**SUBJECT: Transmittal of Changes to Emergency Plan Implementing Procedures (EPIP)**

Confirmation of Transmittal for  
Emergency Planning Documents/Information

**EPIP-TSC-8**

**Title:** CORE DAMAGE ASSESSMENT

Figure 1- Category of Core Damage Based on Containment Post Accident Dose Rates

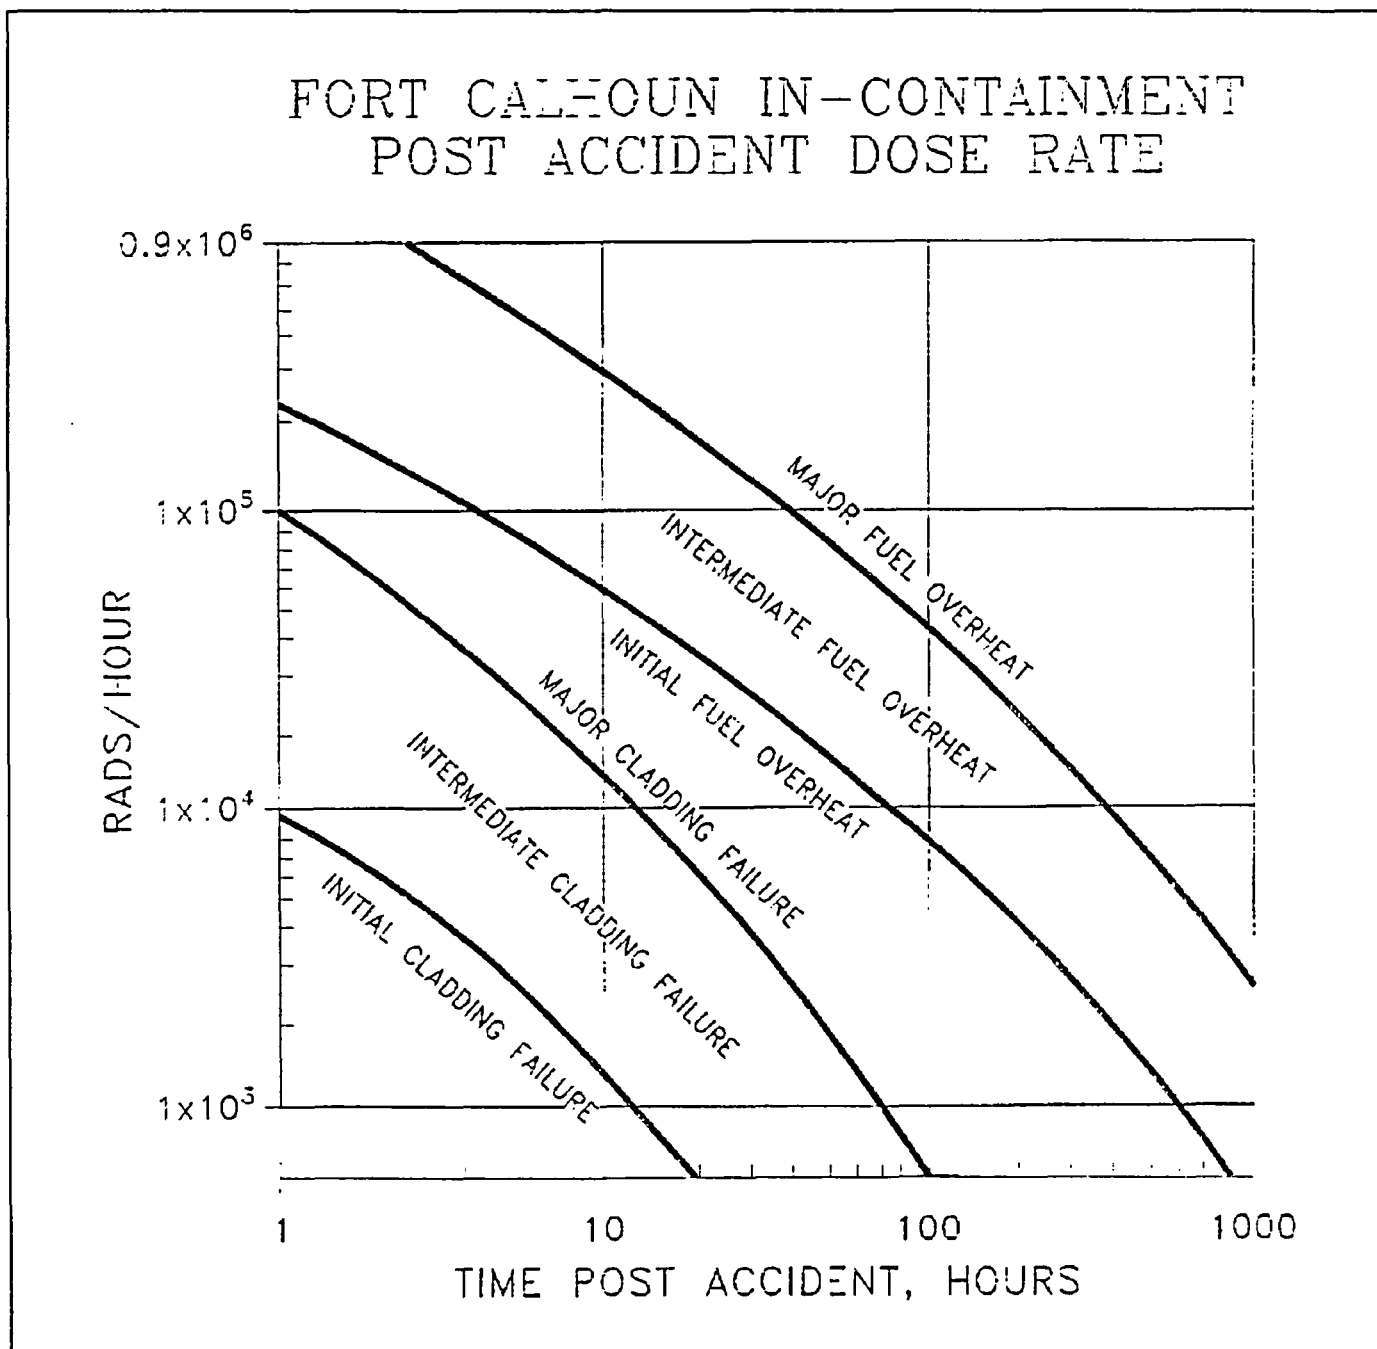
EPIP-TSC-8 was revised to add scale lines to Figure 1 Attachment 6.5 for ease of reading.

Reason for Change: Add lines to graph for ease of reading.
